Benson Delaware Unit #8 API # 30-015-34816 Eddy Co., NM

Convert To Water Injection

Conditions of Approval

Chi Operating Incorporated Benson Delaware Unit - 08, API 3001534816 T19S-R30E, Sec 19, 2500FNL & 660FWL October 8, 2015

MECHANICAL DATA

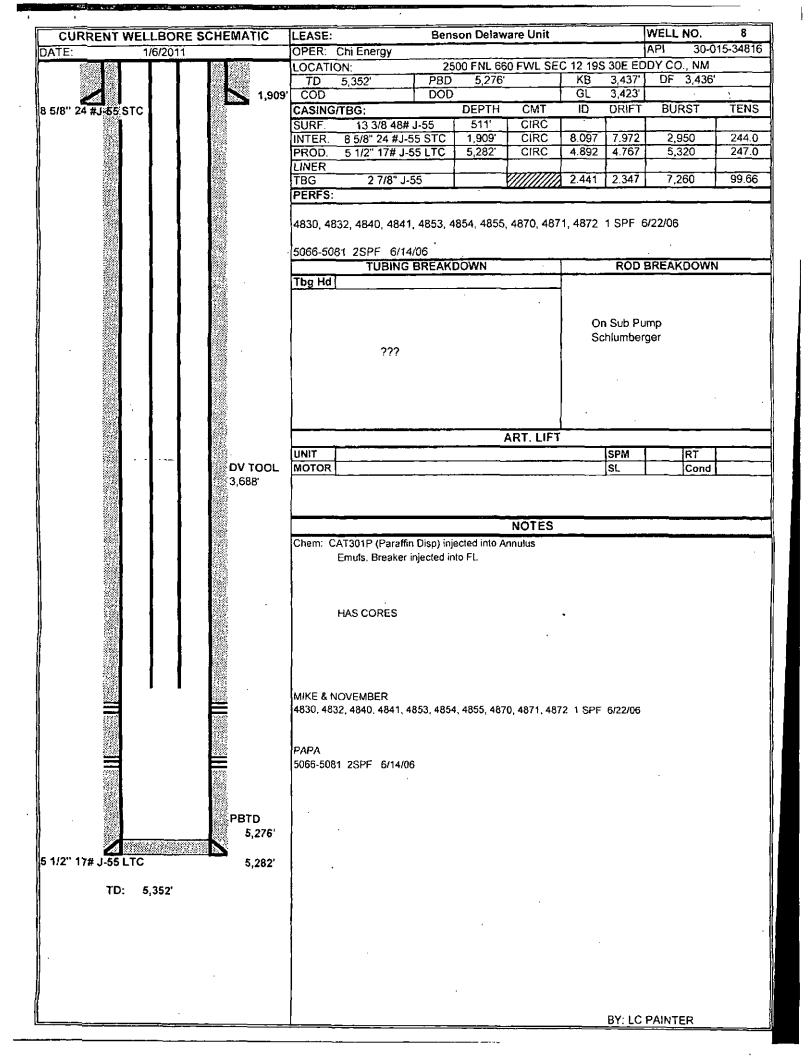
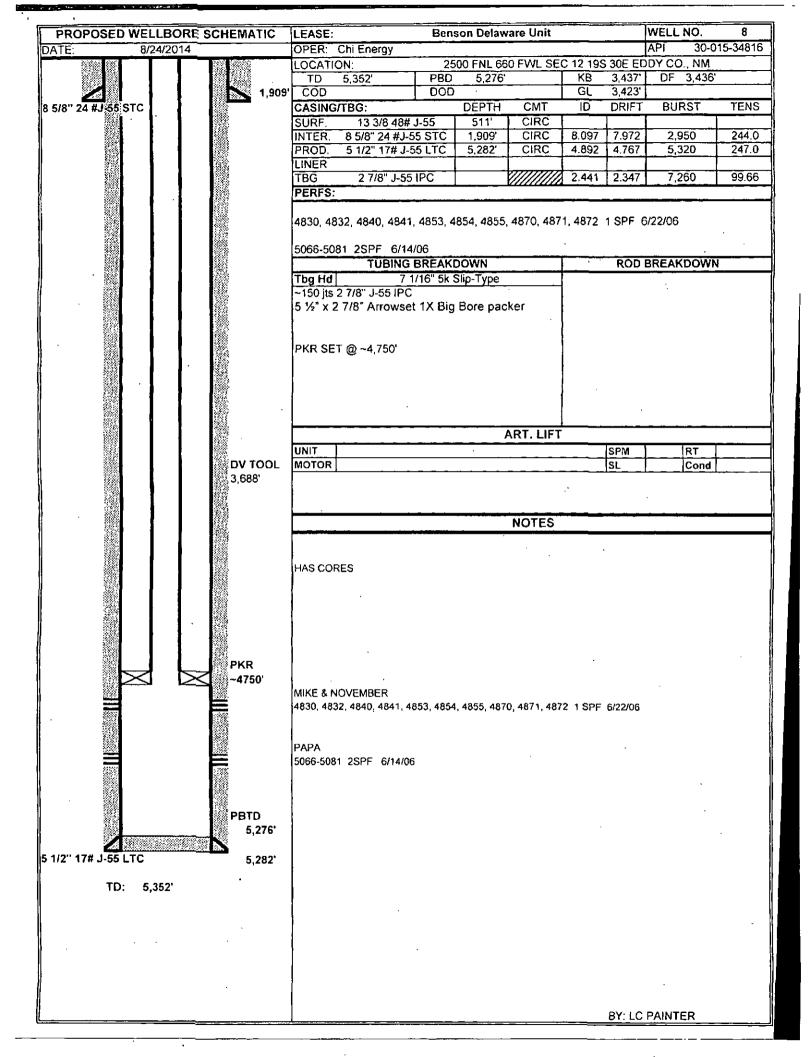
- 8. Perform a charted casing integrity test of 1200 psig. Document the pressure test on a one hour full rotation calibrated (within 6 months) recorder chart registering within 25 to 85 per cent of its full range. Verify all annular casing vents are plumbed to the surface and open during this pressure test. Call BLM 575-200-7902 and arrange for a BLM witness of that pressure test. Include a copy of the chart in the subsequent sundry for this workover.

- 9. Provide BLM with an electronic copy (Adobe Acrobat Document) cement bond log record from 4730' taken with 0psig casing pressure. The CBL may be attached to a pswartz@blm.gov email.
